Please include these comments to the Idaho-Maryland Mine DEIR.

Review of the Idaho-Maryland Mine DEIR Groundwater Model

Figure 3-7 Comparison of Shaft Water Levels with Rainfall

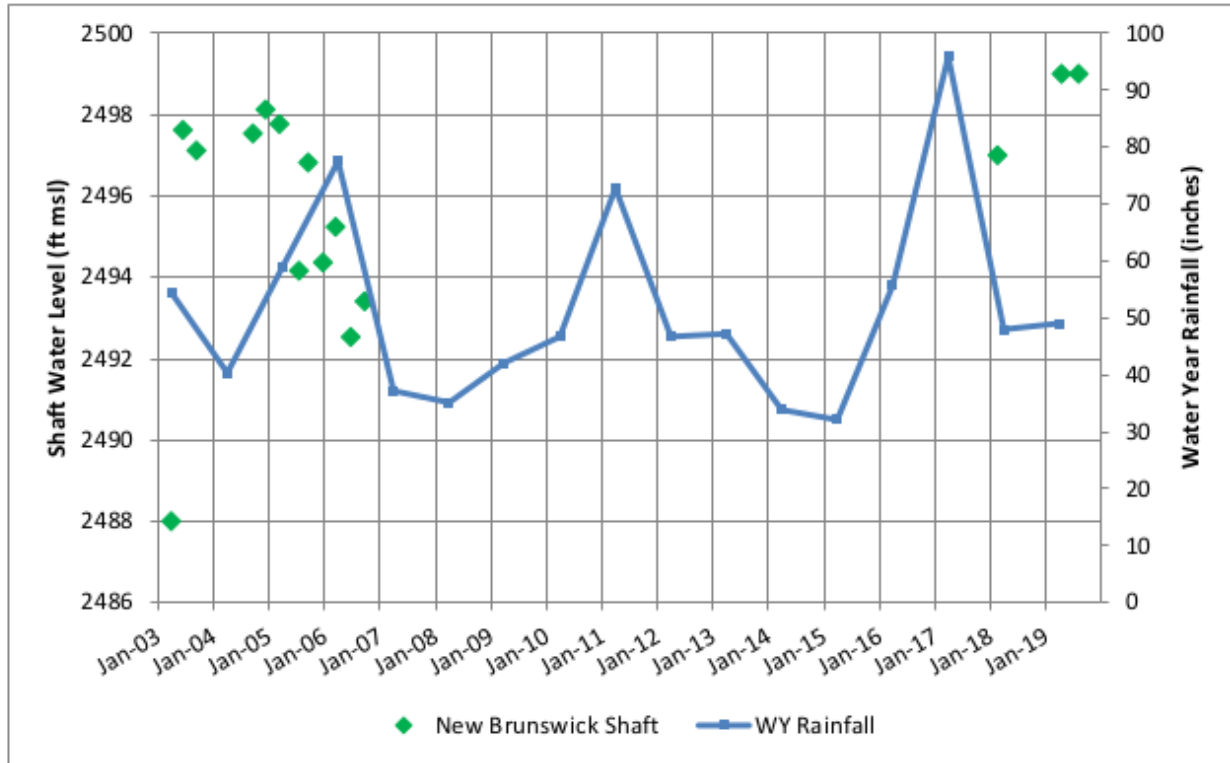
Mine water level data - EMKO argues that the levels of water in the NB Shaft are independent of the seasonal rainfall and provides a graph showing both rainfall and NB Shaft water levels. (see Figure 3-7 below) Unfortunately, the NB Shaft data are very limited. Only about 15 measurements are provided. (Additional issues with the interpretation of the data are discussed in 4, below.) Note that of these, nine are at or above 2497', which is the drain level.

The seasonal interpretation of the New Brunswick Shaft water levels data is flawed. Even without considering the fact that the mine drain outflow rates will create an upper limit to the change in water levels in the NB Shaft, the data does not support the claims made in the EMKO report. EMKO claims that the data “...demonstrate that the variations in the water level in the shaft do not occur on a seasonal basis, and that there is not a consistent correlation between water levels in the shaft and rainfall.” [p30, and Figure 3-7]

There are several errors to this reasoning. First, note that data is sparse, with only 12 samples over a four year period in 2003-2006, plus a single sample in 2018, and two samples in 2019. Also note that the data is taken at

various times of the year, making direct year to year correlations limited. Also note that the annual rainfall year is based upon precipitation from October thru September, and a single data point for each year's rainfall is apparently placed on April 1, in the middle of that year's rain season. (Figure 3-7).

The chart lacks sufficient granularity to be useful. For example, a year's rainfall may be above average, but an NB Shaft measurement taken in December of that year may reflect that the first few months of the rainy season and the preceding last 6-9 months of the prior year's seasonal rainfall, which could be below average even though the rainfall year was recorded as above normal due to rains after December for that year.

In order to detect variation seasonally, it is more useful to look at the total rainfall in the months preceding any particular NB Shaft measurement. Thus, for the NB Shaft value at ~2497' elevation on around Feb 2018, the total rainfall from June 2017 through Feb 2018 was only 25.98". This is below normal. This correlates with a lowered level in NB Shaft. But the higher value of the 2017 total rainfall year reflects higher precipitation from more than 9 months earlier, giving the false impression of non-correlation.

Note also that the 2019 precipitation data is invalid according to precipitation records. The 2019 precipitation should be graphed at 68.15 inches, the correct precipitation for that period. But it is graphed at an incorrect value of 48 inches. Correcting the graph would show a direct correlation between higher precipitation and NB Shaft levels.

In addition, in close examination of the data for 2005, there is a clear drop in levels between the late Winter sample and the mid Summer sample followed by a Fall rebound. Also, again in 2006, there is a clear drop from late Winter to mid Summer followed by a rebound. Thus, data from both of those years **seems to imply that there actually is a seasonal correlation.**

Looking at the graph based upon annual precipitation over multiple years, there does appear to be a downward trend in shaft levels from 2004 to mid 2006. And the annual precipitations were notably below normal from 2003 to December of 2005. So the graph seems to show a multiyear downward trend in the NB Shaft levels with a clear seasonal variations signal also showing in the measurements.

In conclusion, the given EMKO conclusions from the comparison between NB Shaft water levels and seasonal precipitation using figure 3-7 do not hold water. The following are needed:

- Year-round logging of mine water level and outflow should be collected.

- Data should be collected for several years, including at least a year with normal rainfall and a year each with low and high rainfall, in order to establish a baseline for groundwater modeling and impact assessment.
- The data from the outflow and the data showing changes in mine water level can then be compared with granular rainfall data to legitimately make an assessment of the amount of seasonal variation in mine water inflows.
- The data could then be used to provide an estimate of transmissivity from the surface.
